Project Name: Linray Professional Suites

Project Number: DR02-69

TO: DESIGN REVIEW BOARD
FROM: DAYNA BEDNEY, PLANNER I *DB*
THROUGH: LINDA M. EDWARDS, AICP, PLANNING MANAGER *LE*
MEETING DATE: JANUARY 15, 2004
SUBJECT: DR02-69 LINRAY PROFESSIONAL SUITES
W OF SWC LINDSAY ROAD AND RAY ROAD (*AMENDED*)

Approval of a Comprehensive Sign Package for a Lin Ray Professional Suites, located west of the southwest corner of Lindsay Road and Ray Road. (*Amended report modifies case number in staff's recommendation*).

MONUMENT SIGN ELEVATION
Scale: 3/8"=1'-0"

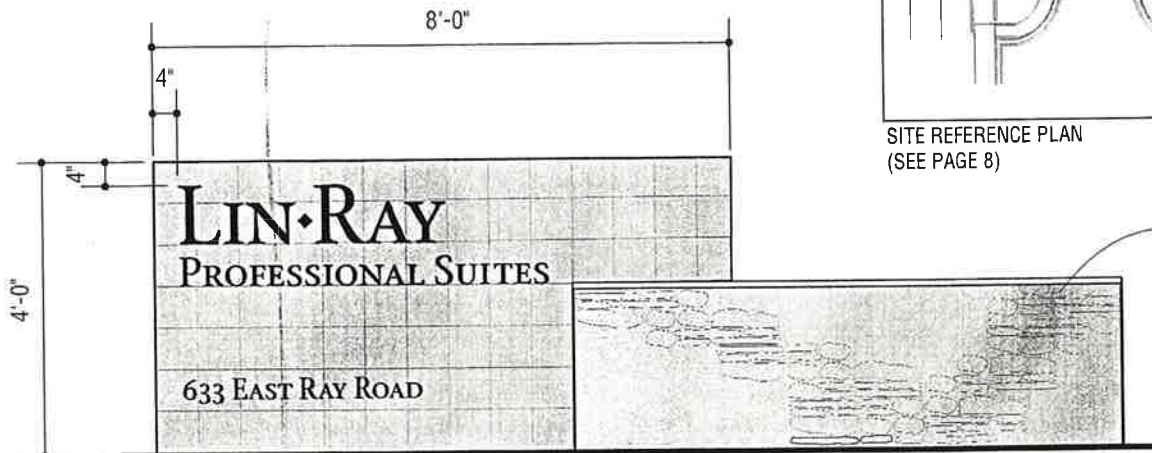
Two entry monument signs are proposed on either side of the drive aisle. The ULDC provides for a maximum height of six (6) feet with a maximum area of thirty-two (32) sq. ft and a minimum setback of three (3) feet from the R.O.W. As proposed, the entry monument signs are four (4) feet in height and thirty-two (32) sq. ft. The sign is integrated into an approximate 16 sq. ft. planter. The signs are required to meet the three (3) foot setback requirement as provided for in the ULDC.

The type face of the sign is stone print roman SC. The materials include 1-1/2' deep reverse pan channel letters, painted to match MPC MP04836 brown/ black with letters stud mounted flush to the wall surface. The colors are consistent with those of the approved structure.

DIRECTORY SIGN ELEVATION
Scale: 1/2"=1'-0"

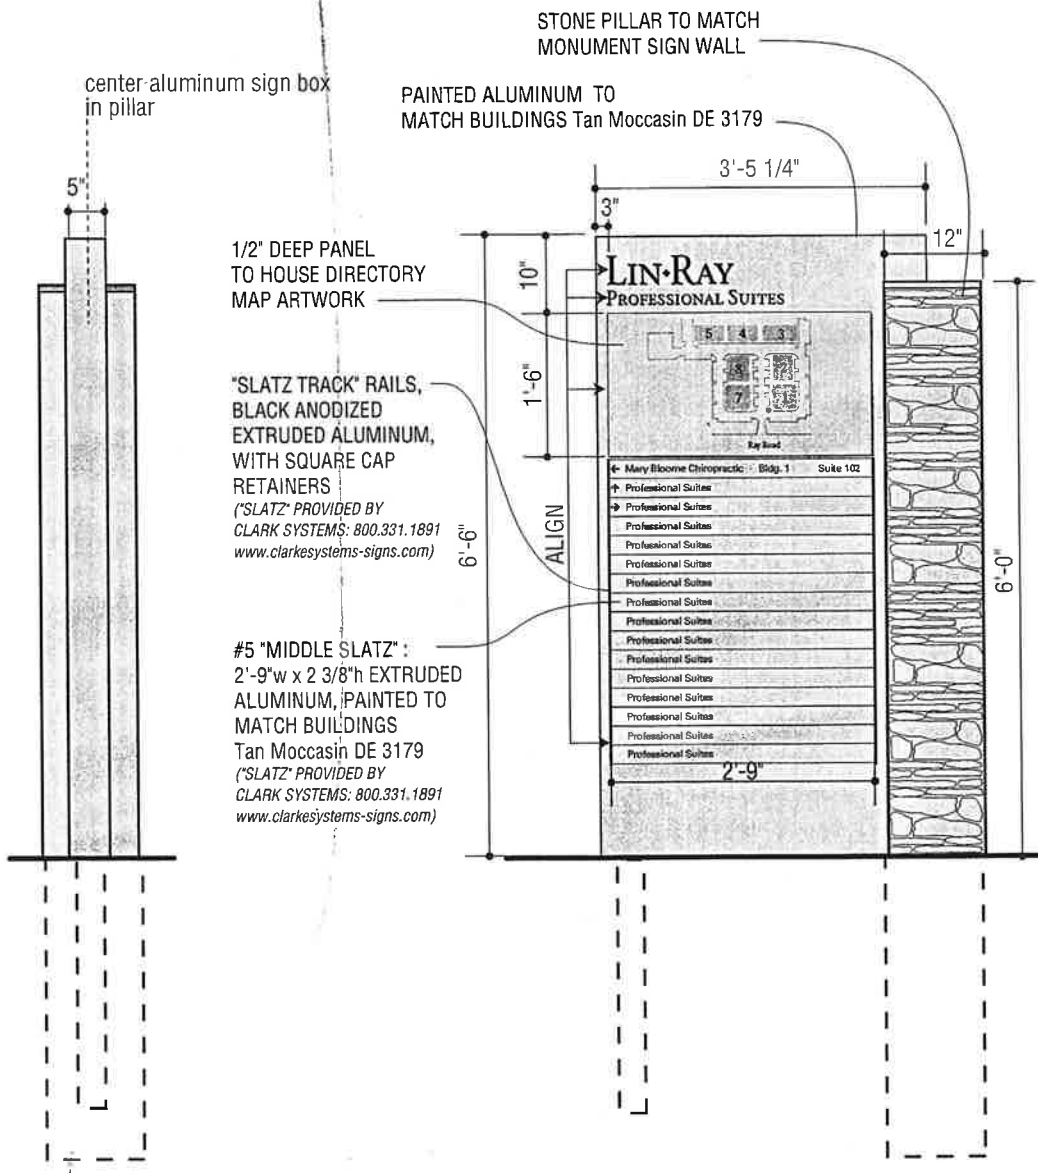
The ULDC provides for a maximum area of forty (40) sq. ft. and eight (8) feet in height for a directory sign. The applicant is proposing one directory sign which shall be setback a minimum of seventy-five (75) feet from any perimeter property line except when abutting other commercial or

industrial zoning districts. The applicant is proposing an area of approximately twenty-five (25) sq. ft. The height proposed is six feet six inches. The directory sign shall be located a minimum of seventy-five feet from the property line.

The colors, materials, and typeface of the directory sign are consistent with those proposed for the entry monument sign. They are both consistent with the colors of the approved structures.
